Highways comments pasted in below, with my responses in red:

The proposal refers to the development of six new dwellings, 4 x 5 bedrooms and 2 x 6 bedrooms, following the demolition of existing buildings.

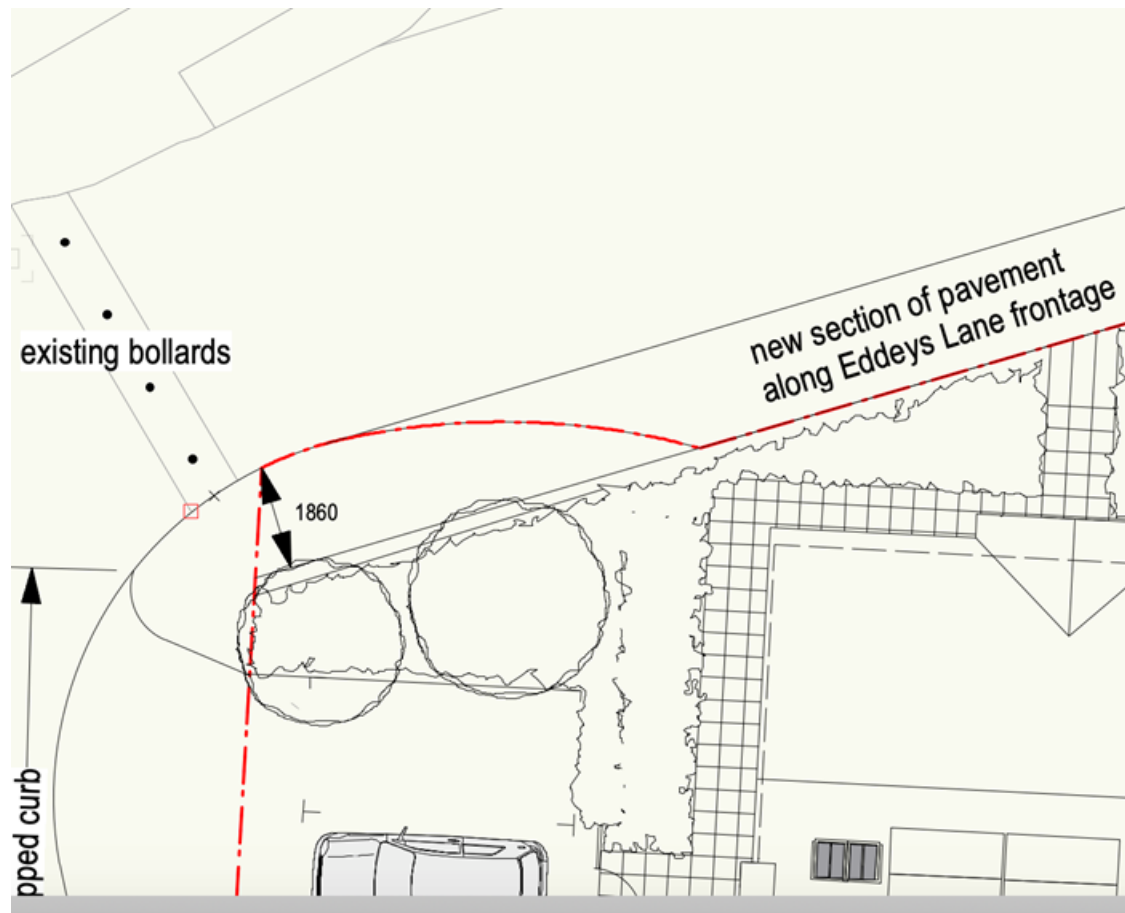
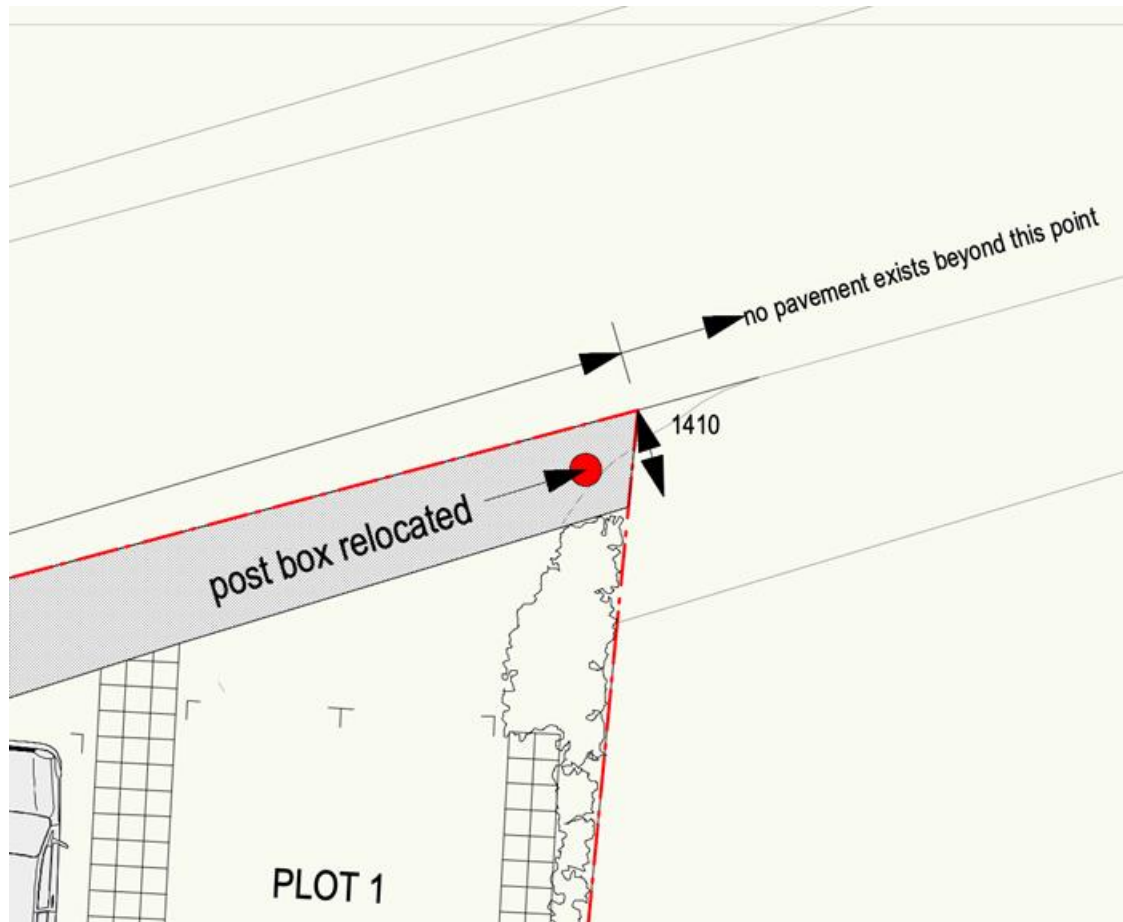
The submitted layout drawing will need some amendments before the Highway Authority can recommend approval. The layout should include a continuous footway connection across the frontage of the site to Eddeys Lane with a preferable (noted) width of 2m to tie into the existing footway to the eastern side of Beech Hill. Currently part of the landscaped area at the corner of Eddeys Lane with Beech hill is within the extent of public highway and would require an extinguishment/stopping up of highway rights. The applicants should ensure that the design has regard to the existing extent of highway boundary as provided to the Architects previously. This issue has been addressed. A continuous pavement has been provided along the entire Eddey's Lane frontage, varying in width from where it adjoins the existing pavement at the junction of Eddey's Lane and Southview Road and continues east until it meets the end of the application site, at which point it is 1.41m wide. Beyond this point there is no existing pavement. The excerpts from TP12 below illustrate:

The extent of the landscaping and parking which lay within the extent of the highway on the approved scheme has been eliminated in the current proposal, such that no part of the associated landscaping or parking now intrudes onto the highway. The extent of the highway which lies within the title plan area of the application site is shown shaded grey on TP12 and is annotated as such for the avoidance of doubt.
